## **BURLINGTON & SIERRA MASTER PLAN**

### **SUBDIVISION**

***Revised for the November 19th meeting:***

# DETAIL SITE PLAN

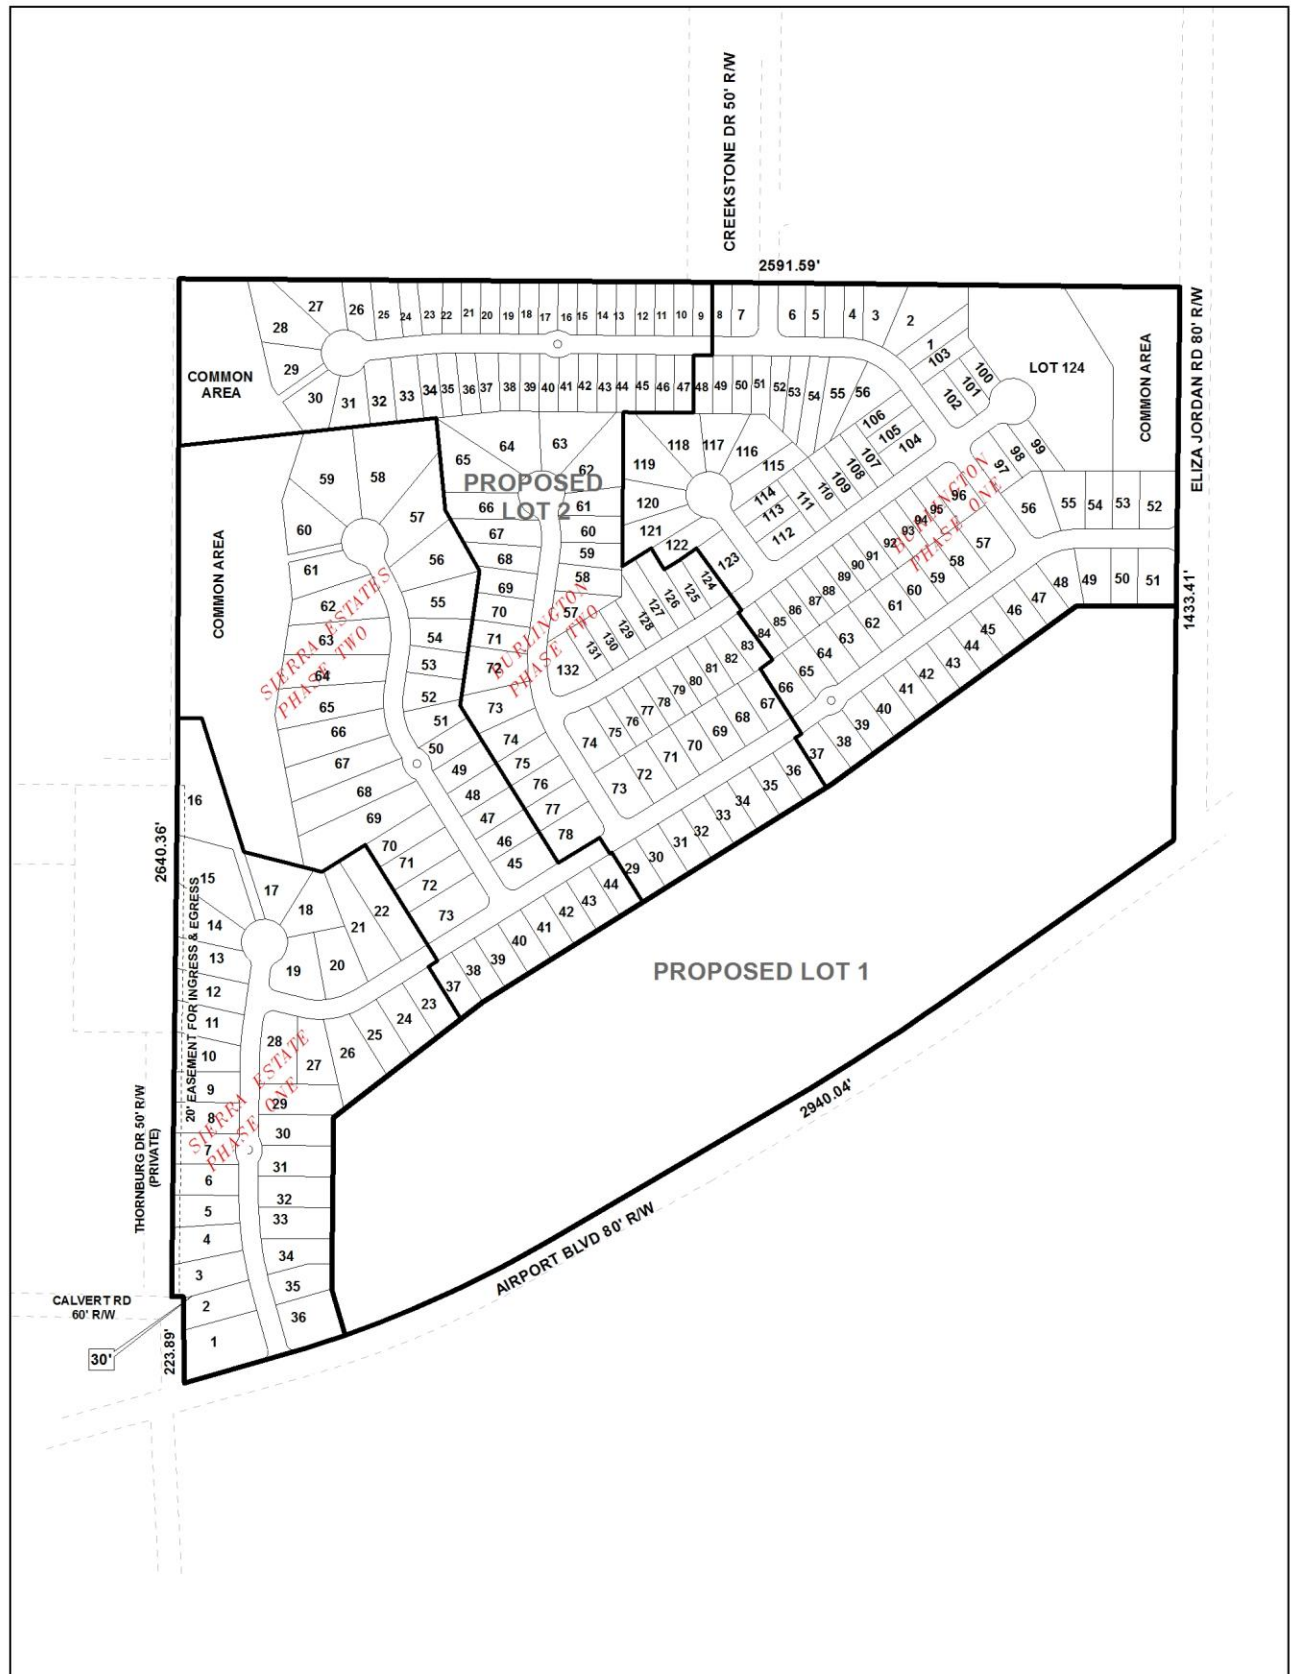
The site fronts Airport Boulevard and Eliza Jordan Road South which are both components of the Major Road Plan with planned 100' rights-of-way. As the current right-of-way width along both frontages is 80', dedication sufficient to provide 50' from the centerline of each would be required. The 25' minimum building setback line is only indicated along the existing frontages of Airport Boulevard and Eliza Jordan Road. This should be revised on the Final Plat so as to be measured from any required street frontage dedication. None of the internal lots have an indicated minimum building setback line; therefore, the plat should be revised to indicate the 25' minimum building setback line along all street frontages.

Access management is a concern along Airport Boulevard and Eliza Jordan Road South; therefore, a note should be required on the Final Plat, if approved, stating that Lots 1 and 36, Sierra Estates Phase One, are denied access to Airport Boulevard, and Lots 51 and 52, Burlington Phase One, are denied access to Eliza Jordan Road South. The plat indicates three common areas without any designated access points. Therefore, dedicated access within the Subdivision should be provided to all common areas. Access should be denied to the common

area along Eliza Jordan Road South from that road. Access should be denied to Thornburg Drive (private road) and Calvert Road North, both along the West side of the site. All lots and common areas should be limited to one curb cut each, with the size, location and design to be approved by Mobile County Engineering.

No lot areas are indicated on the preliminary plat. The plat should be revised to indicate the lot sizes in both square feet and acres. Lots 1 and 36, Sierra Estates Phase One, and Lots 51 and 52, Burlington Phase One, should be revised to indicate lot sizes after any required street frontage dedication.

Section V.D.2. of the Subdivision Regulations establishes minimum lot dimensions and areas. The plat scales to indicate that many of the proposed lots are of substandard width (less than 60' wide at the building setback line) and/or of substandard size (less than 7,200 square feet). Many of the lots are only 50' wide at the setback line and contain as little as 6,900 square feet. And Section V.D.3. states that the depth of lots shall not be more than 3.5 times the width of the lot at the building setback line. Several of the lots exceed the allowable ratio. As there was no justification submitted with the application to allow substandard lot dimensions and areas as an innovative subdivision, and as there are no existing innovative subdivisions within the area approved by the Commission, the subject application cannot be considered for approval as presented.

No drainage easements associated with the common areas, or any easements for that matter, are indicated on the plat. If any easements are proposed, they should be indicated on the preliminary plat.

The site has closed-end streets that exceed 600 feet. Thus, a waiver of Section V.B.6 of the Subdivision Regulations would be required. The plat indicates a compliant turnaround right-of-way diameter of 120 feet and this should be retained on the Final Plat, if approved. Some of the streets which contain more than 30 lots have only one access point. Appendix D of the IFC, requires two points of access for single-family subdivisions with 30 or more lots. Therefore, the applicant should either obtain written approval from the State Fire Marshall to allow one point of access for portions of the Subdivision containing more than 30 lots, or the plat should be revised to provide a second access point for those portions.

The site has property lines at an intersection corner. Section V.D.6. of the Subdivision Regulations requires that *"property lines at street intersection corners shall be arcs having radii of at least 10 feet or shall be chords of such arcs."* The curb radii is depicted on the preliminary plat, and if approved should be depicted on the Final Plat as well.

*The revised plat still indicates the lots on the East-West closed-end street within Burlington, Phase Two, as having only one point of access, that being from the East. As Appendix D of the IFC requires two points of access for single-family subdivisions with 30 or more lots, the applicant should obtain written approval from the State Fire Marshall to allow one point of access for this portion of the Subdivision prior to signing the Final Plat.*

*The applicant has revised the plat to provide access to the land-locked properties adjacent to the West of the proposed Subdivision via a 20' easement for ingress and egress across the rear of Lots 3 – 16, Sierra Estate, Phase One. Therefore, a note should be placed on the Final Plat stating that Lots 3 – 16 are denied access to this easement and to the adjacent Thornburg Drive (private street). A note should be placed on the Final Plat stating that Lots 3 – 16, Sierra Estate, Phase One, are not allowed to place or construct any structure within the 20' easement for ingress and egress. Lots 1 and 2, Sierra Estate, Phase One, adjoin Calvert Road North to the West; therefore, a note should be required on the Final Plat stating that those lots are denied access to Calvert Road North.*

*The revised plat does not address some of the other deficiencies initially noted in the proposed Subdivision. The two large common areas on the West have been provided with access points; however, the common area along Eliza Jordan Road South still has no access point indicated. An internal access to this common area must be provided, not one from Eliza Jordan Road South, prior to signing the Final Plat.*

**RECOMMENDATION** With waivers of Sections V.D.2. and V.D.3. of the Subdivision Regulations, the plat meets the minimum requirements and is recommended for Tentative Approval, subject to the following conditions:

- 1) recording of the Eliza Jordan Corner Subdivision prior to the signing of the Final Plat for any phase of the Burlington or Sierra Subdivisions;*
- 2) dedication sufficient to provide 50' from the centerline of Airport Boulevard;*

- 3) dedication to provide 50' from the centerline of Eliza Jordan Road South;*
- 4) dedication of a 25' corner radius at the intersection of Airport Boulevard and Eliza Jordan Road South;*

- 5) illustration of the 25' minimum building setback line along all street frontages, revised along Airport Boulevard and Eliza Jordan Road South as to be measured from any required dedication;*

- 6) placement of a note on the Final Plat stating that Lots 1 and 36, Sierra Estates, are denied access to Airport Boulevard;*
- 7) placement of a note on the Final Plat stating that Lots 51 and 52, Burlington, Phase One, are denied access to Eliza Jordan Road South;*

- 8) revision of the plat to provide access to the common area along Eliza Jordan Road South from within the Subdivision and not from Eliza Jordan Road South;*

- 9) placement of a note on the Final Plat stating that Lots 3 – 16, Sierra Estates, Phase One, are denied access to the 20' easement for ingress and egress along the West end of the lots and are also denied access to Thornburg Drive (private street) adjacent to the West;*

- 10) placement of a note on the Final Plat stating that Lots 1 and 2, Sierra Estates, Phase One, are denied access to Calvert Road North;*
- 11) placement of a note on the Final Plat stating that Lots 3 – 16, Sierra Estates, are not allowed to place or construct any structures within the 20' easement for ingress and egress;*

- 12) placement of a note on the Final Plat stating that all lots and common areas are limited to one curb cut each, with size, location and design to be approved by Mobile County Engineering;*

- 13) *revision of the plat to label all lots with their sizes in square feet and acres, or the furnishing of a table on the Final Plat providing the same information;*

- 14) *lot sizes for Lots 1 and 36, Sierra Estates, Phase One, and Lots 51 and 52, Burlington, Phase One, to be calculated to reflect their sizes after any required dedication;*

- 15) *submittal of a County Letter of Acceptance for the constructed new streets prior to signing the Final Plat;*
- 16) *submittal of written approval from the State Fire Marshall allowing one point of access for lots within Burlington, Phase Two, prior to signing the Final Plat;*
